**REVISED RESPONSE TO REQUEST FOR ADDITIONAL INFORMATION****APR1400 Design Certification****Korea Electric Power Corporation / Korea Hydro & Nuclear Power Co., LTD****Docket No. 52-046****RAI No.: 255-8285****SRP Section: 03.08.05 – Foundations****Application Section: 03.08.05****Date of RAI Issue: 10/19/2015**

**Question No. 03.08.05-7**

Figure 1. Detailed Section in the NI basemat

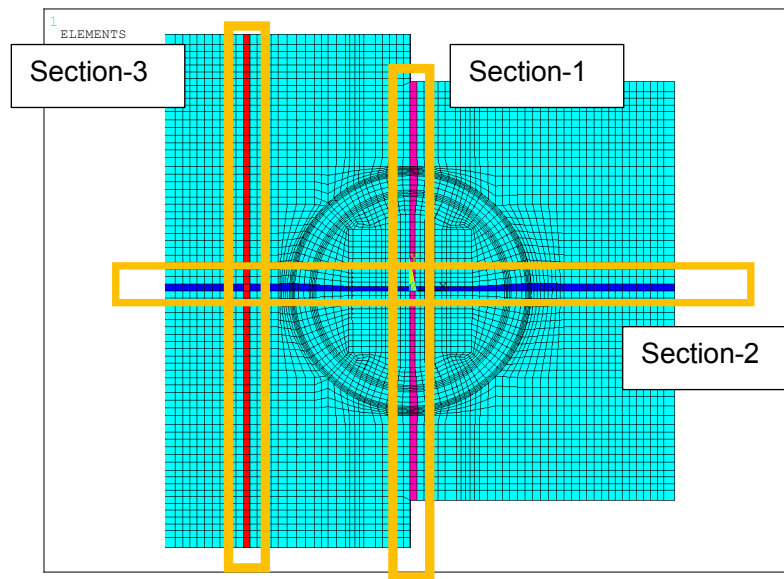
In DCD Tier 2, Section 3.8.6.4, "Design and Analysis Procedures," the applicant stated "The maximum differential settlement of foundation is 12.7 mm per 15.24 m (0.5 in per 50 ft) within NI common basemat. The maximum differential settlement between buildings is 12.7 mm (0.5 in) based on enveloping properties of subsurface materials. " However, it is not clear to the staff how the construction sequence and differential settlement of foundations were considered in the load and load combinations. Therefore, the applicant is requested to describe how the construction sequence and differential settlement of foundations were considered in the load and load combinations. Also, DCD Section 3.8.5 should be updated accordingly.

To judge whether the soft soil case is governed for construction sequence analysis, the moment diagram for each section on profiles (S1, S8) is compared under abnormal/extreme environment load combination (LC08). Figure 1 shows the detailed sections in the basemat.
